# STAFF RECOMMENDATION

NCPC File No. 6669

**UNITED STATES INSTITUTE OF PEACE**  
NEW HEADQUARTERS AND PUBLIC EDUCATION CENTER  
23<sup>rd</sup> Street and Constitution Avenue, NW  
Washington, D.C.

October 26, 2006

### LUMINANCE STUDY OF LINCOLN MEMORIAL

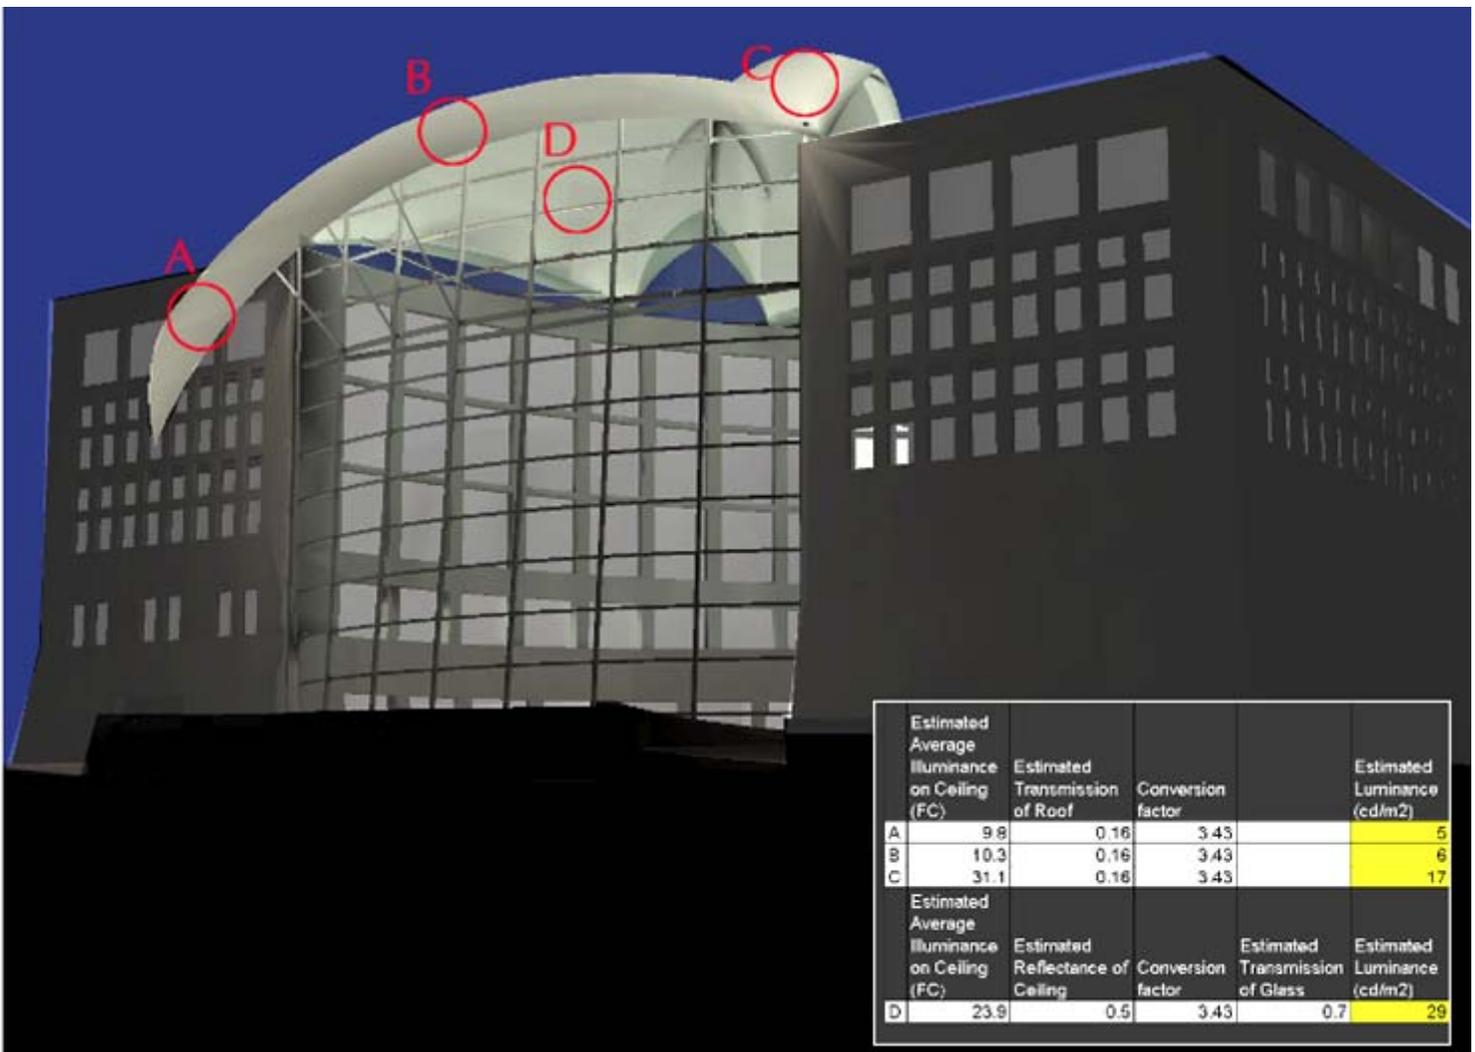
To quantify the brightness of the monuments in the vicinity and to analyze the planned lighting of the new USIP building, the applicant measured the luminance of nearby memorials, and other prominent buildings in late February 2006. Luminance is a measure of light intensity of a surface

in a given direction. The unit of measure is candela per square meter. A candela is roughly equal to the quantity of light given by the flame of a single candle in all directions. The Lincoln Memorial is the most significant monument for comparison of light effects because of its proximity and ability to be viewed simultaneously with the USIP building. The brightest areas of the Lincoln Memorial facades were measured at approximately 11 candela per square meter.

**PRELIMINARY DESIGN OF USIP GENERAL LANDSCAPE PLAN**

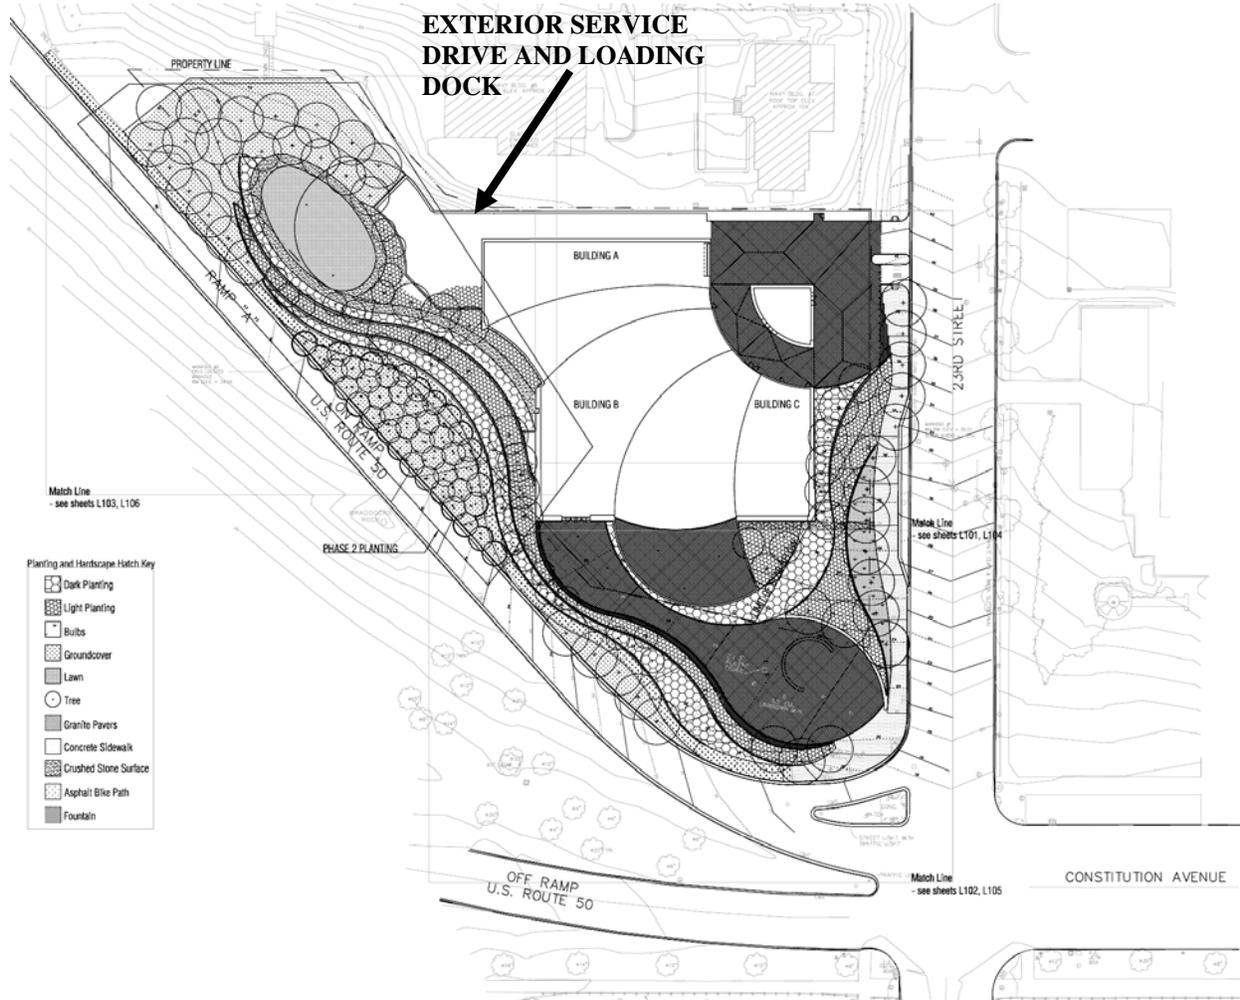
In addition to the detailed review of lighting during preliminary design, the USIP further refined the design of the entry areas of the building and established that two sets of flagpoles are to be used in the site development. Additionally, a single row of fifteen bollards will be utilized at the port cochere to clearly establish, at the upper level, the pavement edge for motor vehicles using this turning area near the site entry stairway.

Finally, the preliminary site design firmly establishes the onsite vehicle entrance configuration with the revised service drive relocated to the north perimeter boundary. However, the parking attendant's booth is not well depicted regarding its basic design and fenestration and must be submitted with greater detail in the next submission. And while the preliminary proposal has provided revised information and detail on the building's entry and site grading adjacent to the structure's perimeter, additional documentation is lacking for the project's complete grading and landscaping plan.

- Complete and fully labeled and detailed site landscape planting plans. These plans shall include a planting design that establishes a vegetation buffer or screen at the west and southwest area adjacent to the exterior building loading dock area, as an initial component of the project construction. This planting must effectively screen this area with evergreen trees for an all-season result.

**BOLLARD PLACEMENT DESIGN AT BUILDING PORT COCHERE**

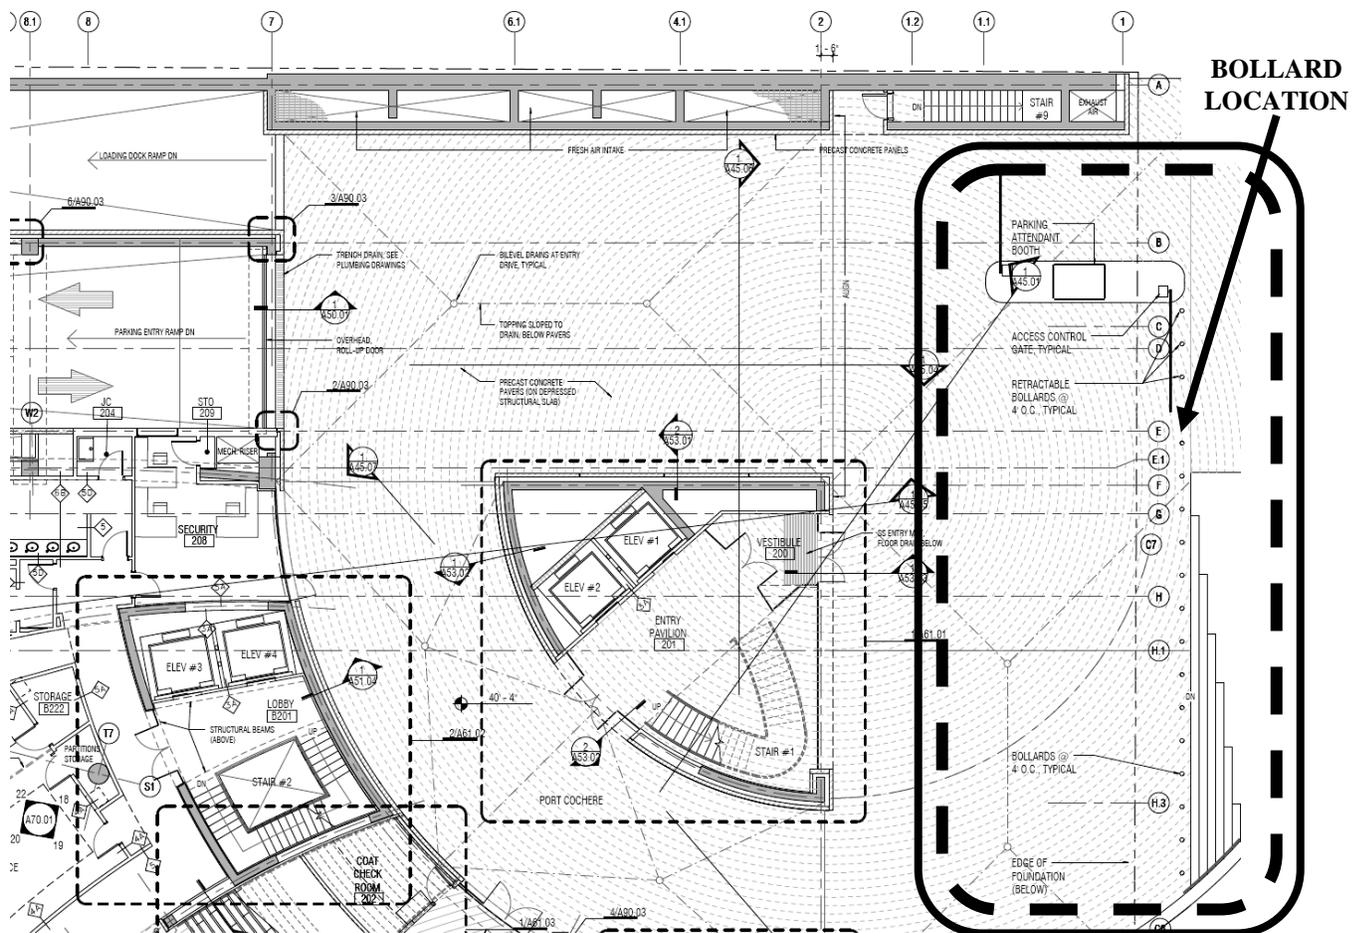
The staff recommends **approval of the preliminary site and building plans by the Commission, with conditions.** The design is intended to establish the headquarters as a symbolic structure along the streetscape. The use of the site at the corner of 23<sup>rd</sup> Street and Constitution Avenue anchors the corner area with a design that gives a defined presence and form to both the site and the public space area of the corner, and thus provides an added gateway presence to Constitution Avenue, NW. The building's form will be highlighted by controlled building light carefully balanced to not overwhelm the Constitution Avenue corridor nor adversely affect adjacent important memorials and important buildings of the vicinity. Staff has determined that while the objective of 11 candela per square meter luminance for the building's overall surface area is desirable as a measured goal, the actual visual appearance in the context of other environmental lighting inputs to the specific site may affect or alter that luminance limit as an overall visual composition. This luminance limit will be jointly established by the Executive Director in consultation and coordination with the Commission of Fine Arts, the National Park Service, and the District of Columbia Historic Preservation Officer. Once this reviewed luminance limit is observed and established, that limit will be the maximum allowable lighting to be provided to the USIP building and shall be documented in writing and included in the operations and maintenance manual for the building provided to the Commission.
